Project	IEEE 802.16 Broadband Wireless Access Working Group < http://ieee802.org/16 >	
Title	Enhancements to Dynamic Medium Acquisition	
Date Submitted	2008-03-09	
Source(s)	Paul Piggin NextWave Wireless Unit 7 Greenways Business Park Bellinger Close Chippenham, Wiltshire SN15 1BN, UK.	Voice: 44 1249 800 100 Fax: 44 1249 800 101 ppiggin @ nextwave.com
Re:	Letter Ballot #29a of IEEE P802.16h/D4.	
Abstract	To date LBT (Listen Before Talk) as realized by the DMA (Dynamic Medium Acquisition) algorithm provided coexistence between 802.16h and 802.11y. The contribution details enhancements to the DMA algorithm that provides 802.16h to 802.16h coexistence, in addition to 802.16h to 802.11y coexistence.	
Purpose	Refine the definition of LBT (Listen Before Talk) and DMA (Dynamic Medium Acquisition) in IEEE P802.16h/D4 based on the latest simulation results.	
Notice	<i>This document does not represent the agreed views of the IEEE 802.16 Working Group or any of its subgroups. It represents only the views of the participants listed in the "Source(s)" field above. It is offered as a basis for discussion. It is not binding on the contributor(s), who reserve(s) the right to add, amend or withdraw

Figure h200803-01 – A detailed example of 2 802.16 and 1 802.11 systems sharing the medium over 3 frame intervals. 802.16 System 2 has Frame N, 802.11 uses Frame N+1, and 802.16 System 2 claims Frame N+2. 802.16 System 1 claims Frame N+3.

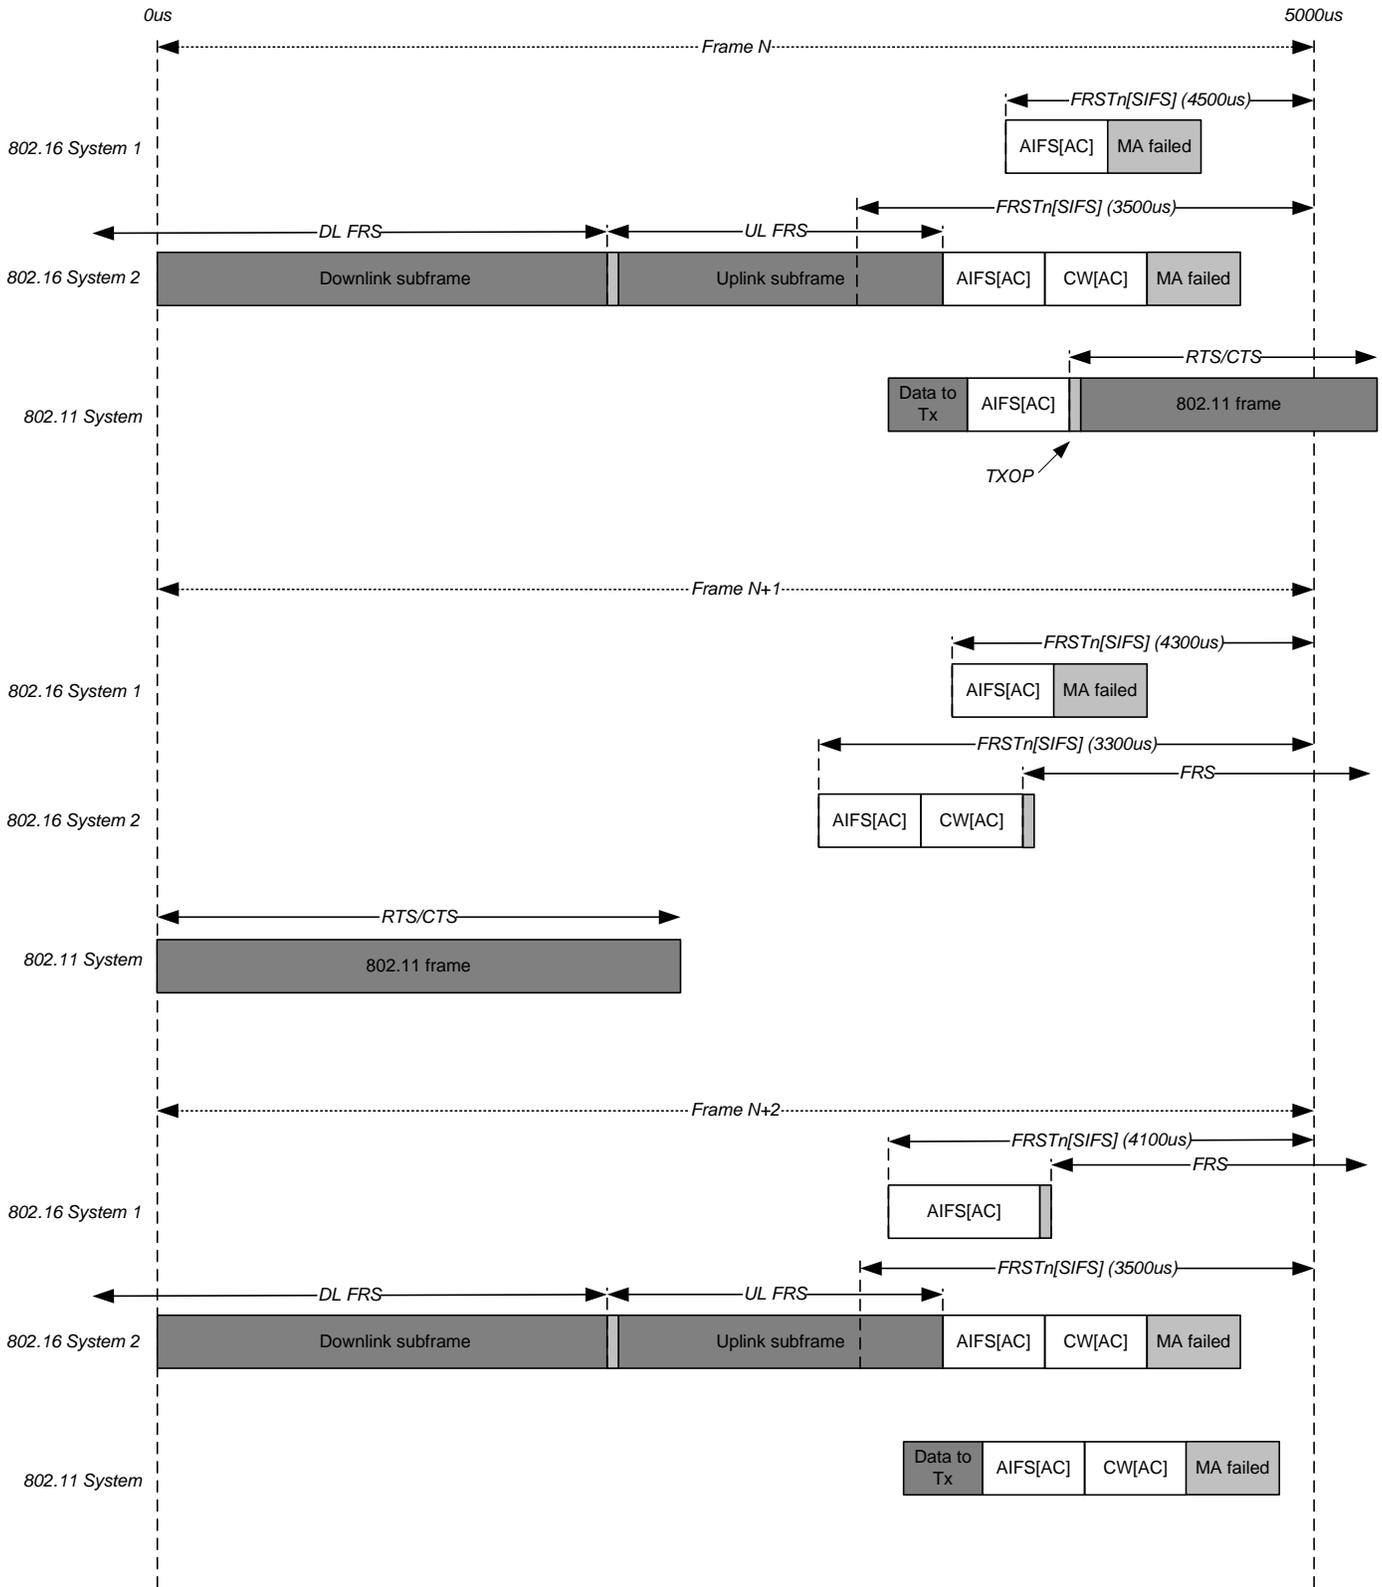
An example of the usage of the DMA discovery protocol is given in figures h200803-01.
